**SAN LORENZO VALLEY WATER DISTRICT
CROSS COUNTRY PIPELINE CONSTRUCTABILITY
PEER REVIEW OF FREYER & LAURETA STUDY AND MEMO**

**Peer Review of March 2022 Study and
Draft Supplemental Evaluation Dated April 6, 2022**

24 NOVEMBER 2022
PROJECT NO. 12196

FIGURE 1C
 PROJECT: 12196
 Date: 10/24/2022

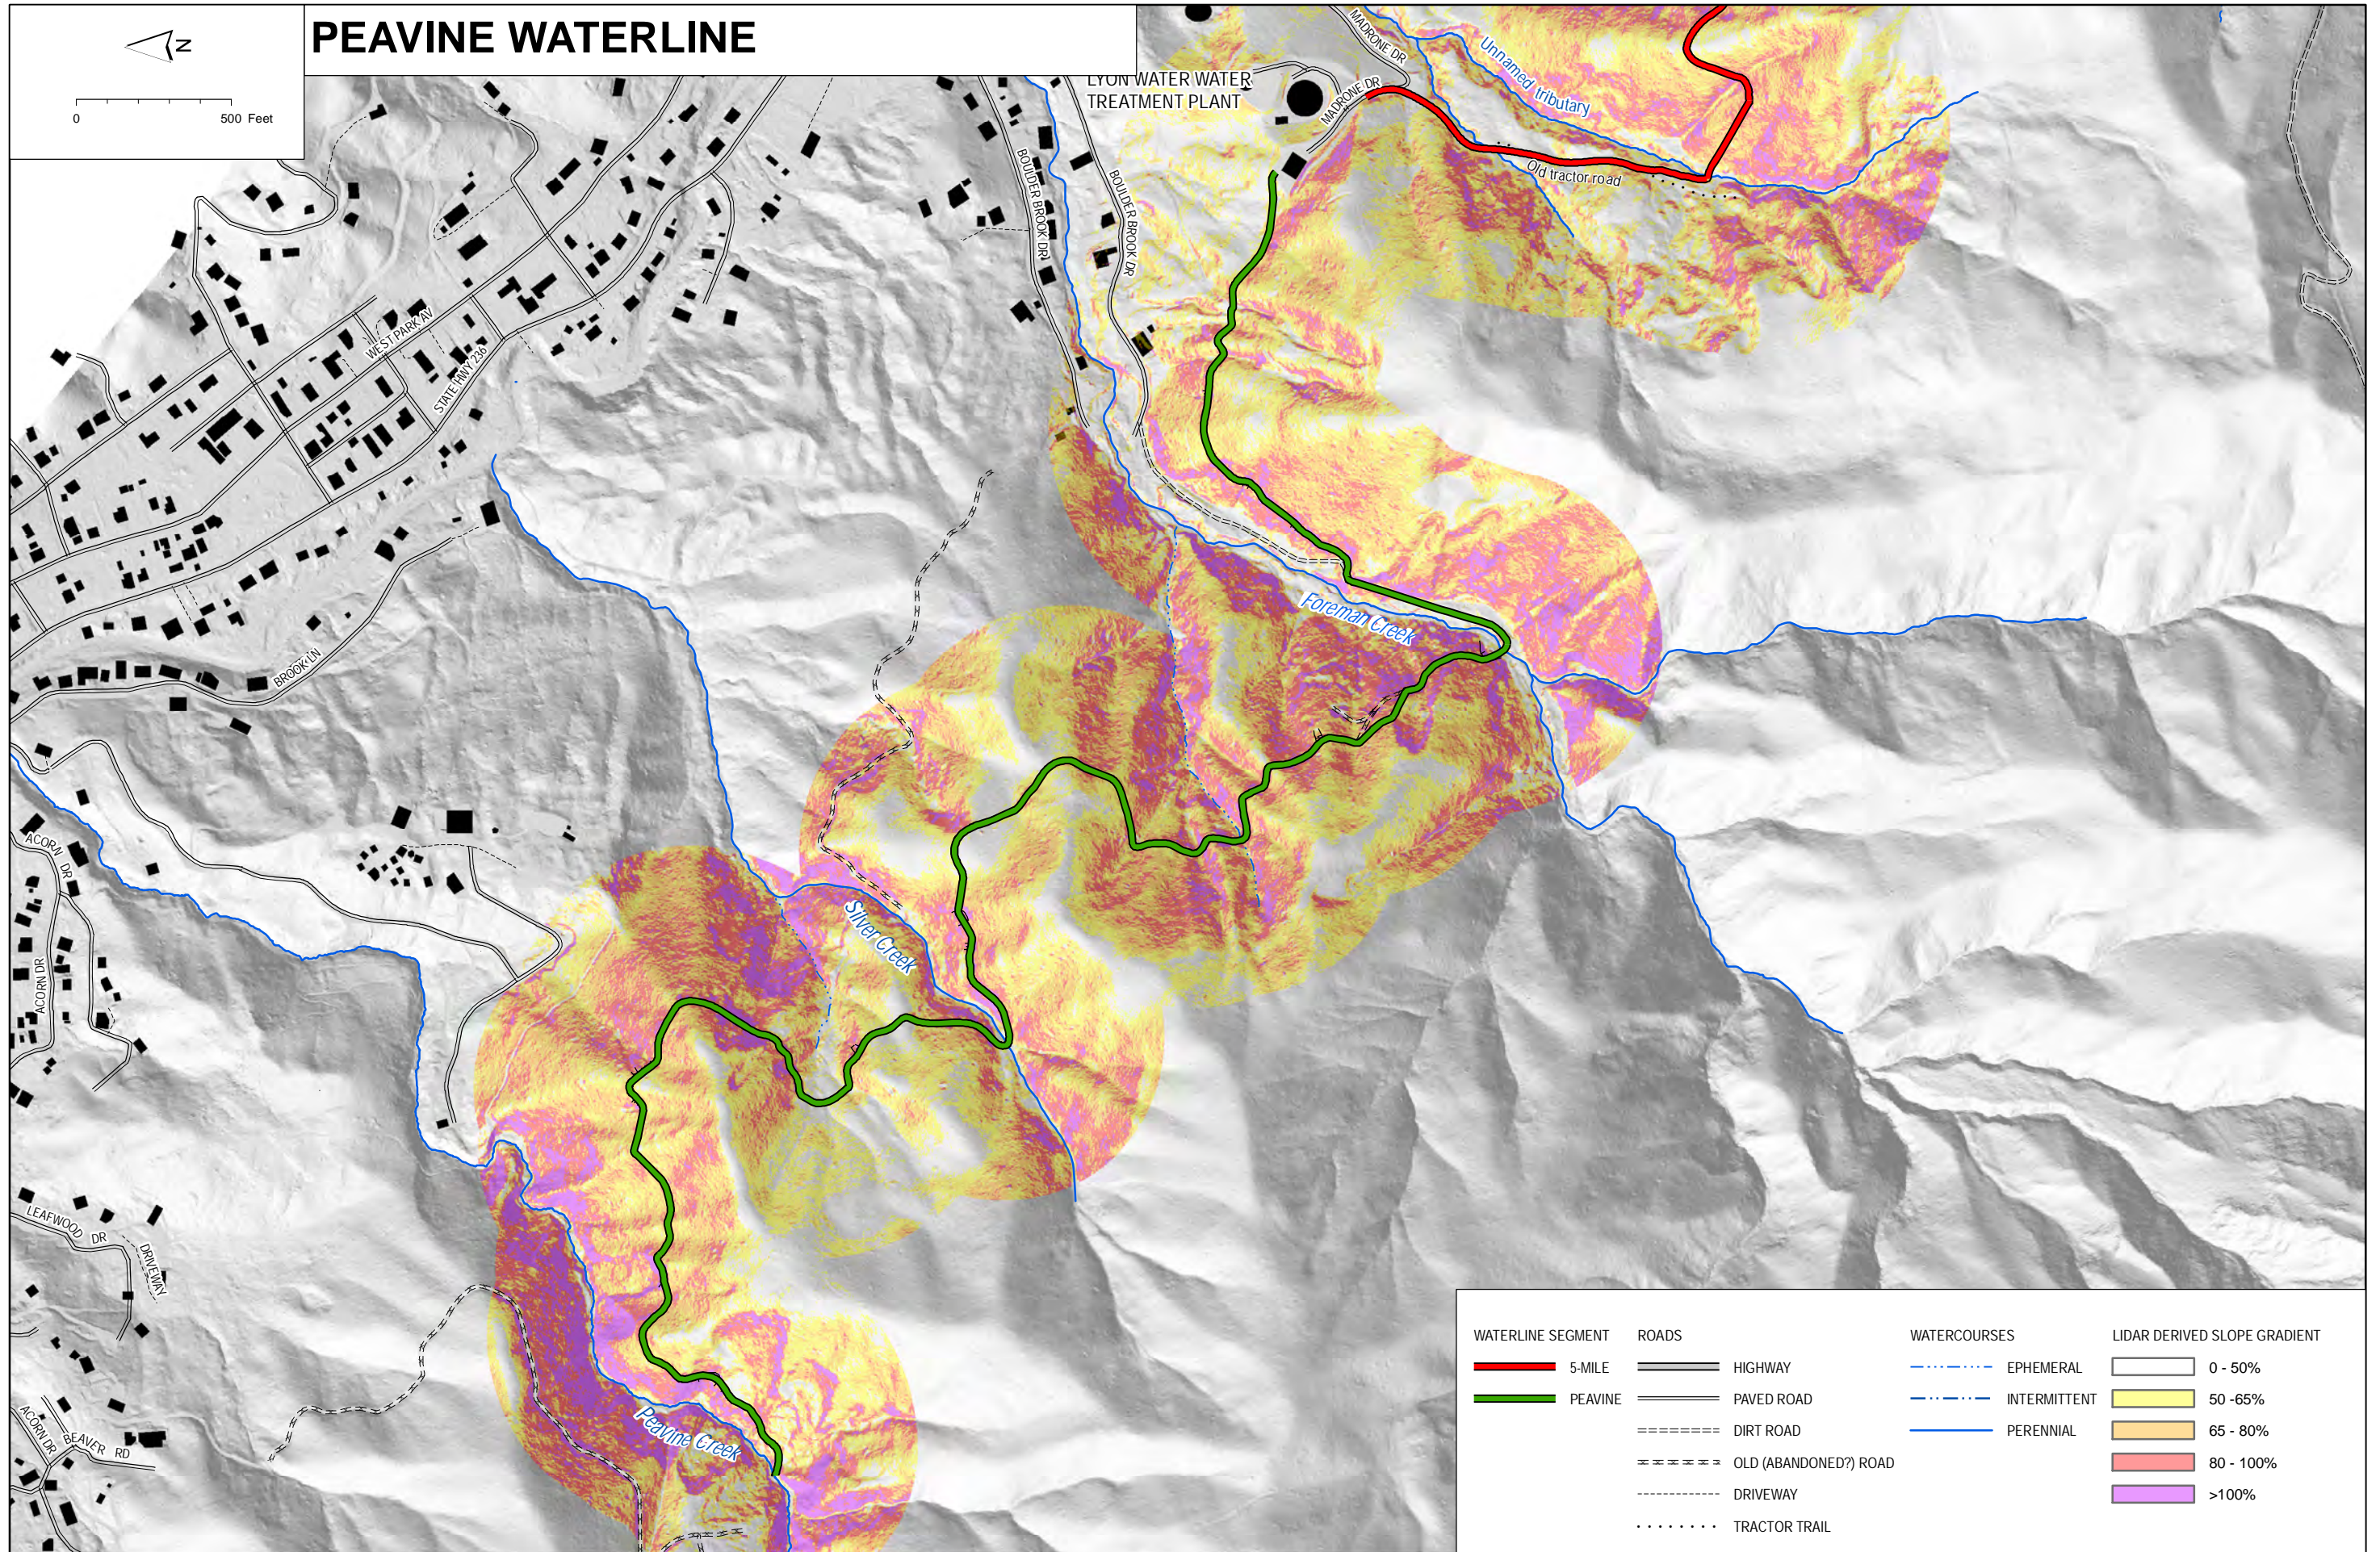
To further evaluate topographic conditions along the alignment, the HKA team generated a slope map of the project area based on a GIS analysis of the 2020 Santa Cruz County, CA LiDAR-derived bare earth digital elevation model (DEM)(NOAA, 2020) coupled with field observations. LiDAR (Light Detecting And Ranging) is a technology that uses lasers to determine the distance to surfaces or objects and can be used to generate relatively accurate measurements of ground elevation. The results were filtered to removal small areas less than 1,000 square feet that were either steeper or gentler than the surrounding ground and which, in our opinion, is generally not representative of the larger average site conditions. The slope map generated for the project area is depicted in Figure 1.

Our LiDAR analysis (See Figure 1A, B and C in Appendix A and Table 1 on Page 20) and the field reconnaissance suggests that about 87% of the alignment is adjacent to slopes steeper than 50% = 2:1(H:V). This difference corresponds to approximately 13,000 feet (lf) of additional alignment that may require retaining structures. Using the F&L unit price cost estimate of \$700/lf, an additional 37%
